SERVICE BULLETIN

NACELLE - EXHAUST - THRUST REVERSER, HYDRAULIC HOSE CLAMPING - ADDITION OF - CATEGORY
CODE 6 - MOD.NAC-78-0050

V2500-NAC-78-0050

Thrust Reverser Opening Actuator Hose Clamping Modification
Fig.1

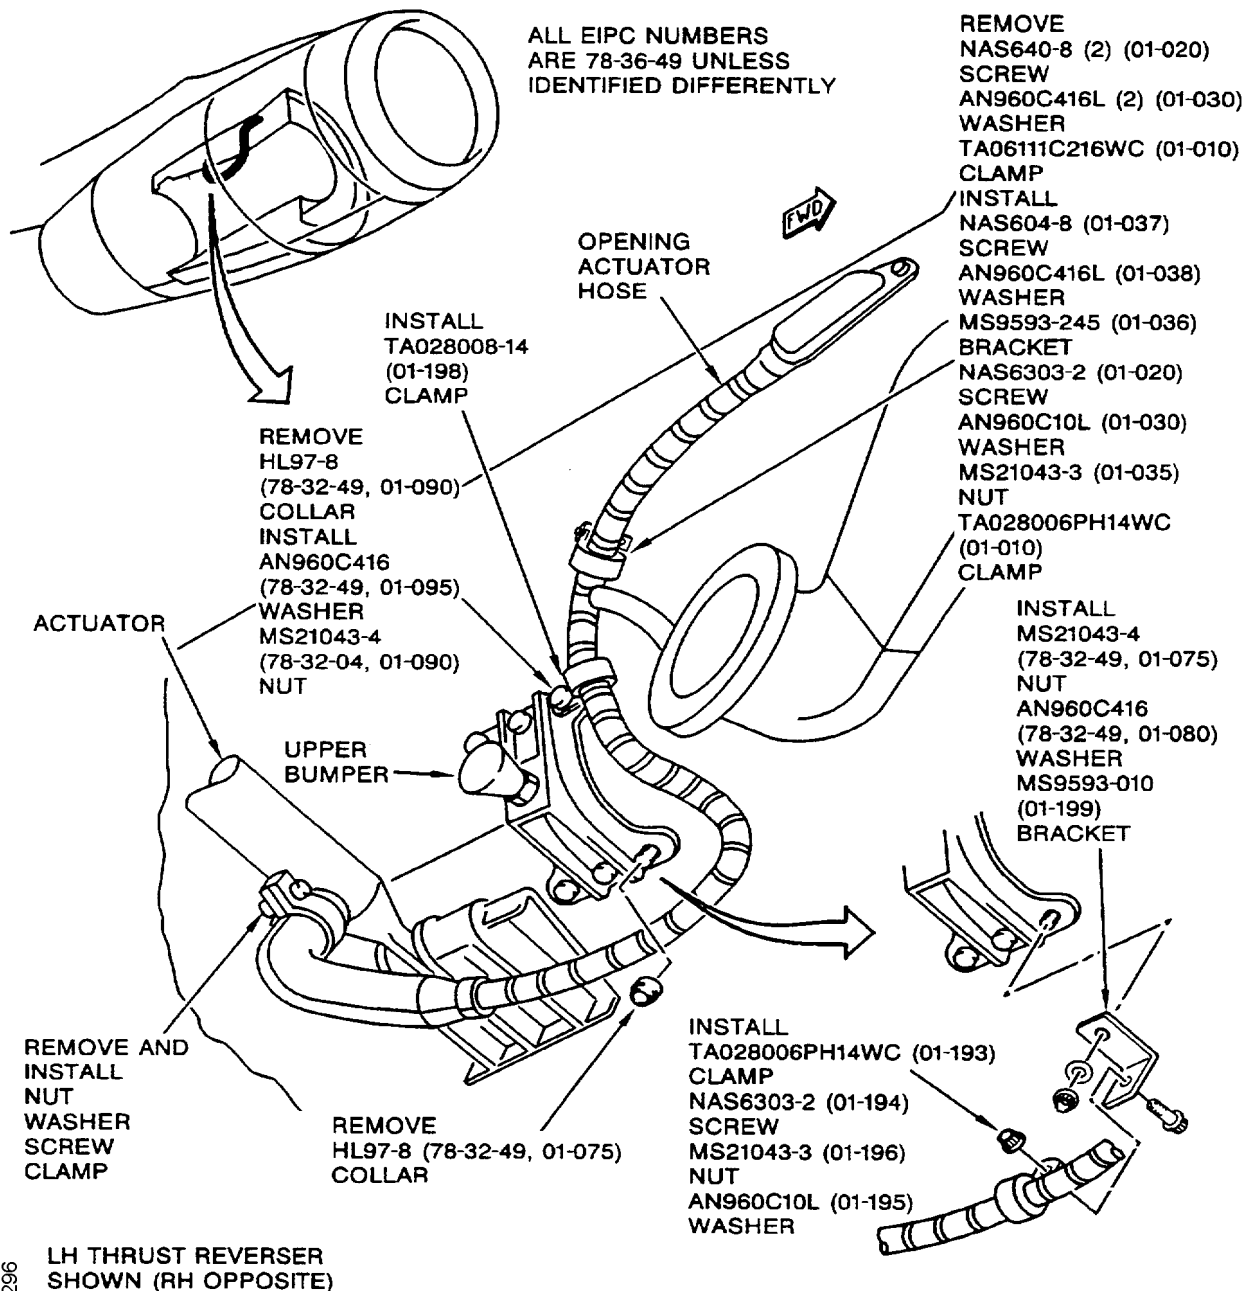
This modification adds three clamps to the Thrust Reverser Door opening actuator hydraulic hose to keep it from touching the engine. This modification is to be done on both the left and the right hand Thrust Reverser halves.

(1) Modify the attachment of the opening actuator hose.

- (a) Remove the screws, washers, and clamps that attach the hose to the heat shield. Keep one NAS604-8 screw, discard the remainder of the remainder of the hardware. Refer to Figure 1.
- (b) Remove the screw, washer, nut and clamp from the hose end cover attached to the actuator. Keep the hardware.
- (c) Remove the collars from the two Hi-Lok pins on the upper bumper.
- (d) Install the MS9593-010 bracket (long side on the bumper) on the lower hi-lok pin on the upper bumper with AN960C416 washer and MS21043-4 nut. Tighten the nut to a torque of 50-70 lb-in (5.6 -7.9 N.m).
- (e) Attach the hose to the bracket with the TA028006PH14WC clamp, NAS6303-2 screw, AN960C10L washer, and MS21043-3 nut. Tighten the nut fingertight.
- (f) Attach the hose to the upper hi-loc pin with the TA028008-14 clamp, AN960C416 washer, and MS21043-4 nut. Tighten the nut fingertight.

- (g) Attach the MS9593-245 bracket to the heat shield with the NAS604-8 screw and AN960C416L washer in the forward hole.
- (h) Attach the hose to the MS9593-245 bracket with the TA028006PH14WC clamp, NAS6303-2 screw, AN960C10L washer, and MS21043-3 nut. Tighten the NAS604-8 screw to a torque of 50-70 lb-in. (5.6-7.9 N.m) and tighten the MS21043-3 nut fingertight.
- (i) Put the hose and the clamps into position to minimize stress and preload on the hose.
- (j) Tighten the nuts that attach the clamp and bracket to the bumper to a torque of 50-70 lb-in. (5.6-7.9 N.m). Tighten the nuts that attach the clamps to the brackets to a torque of 20-25 lb-in. (2.3-2.8 N.m).
- (k) Attach the hose end cover to the hose with the clamp, screw, washer, and nut. Tighten the nut to a torque of 20-25 lb-in (2.3-2.8 N.m).
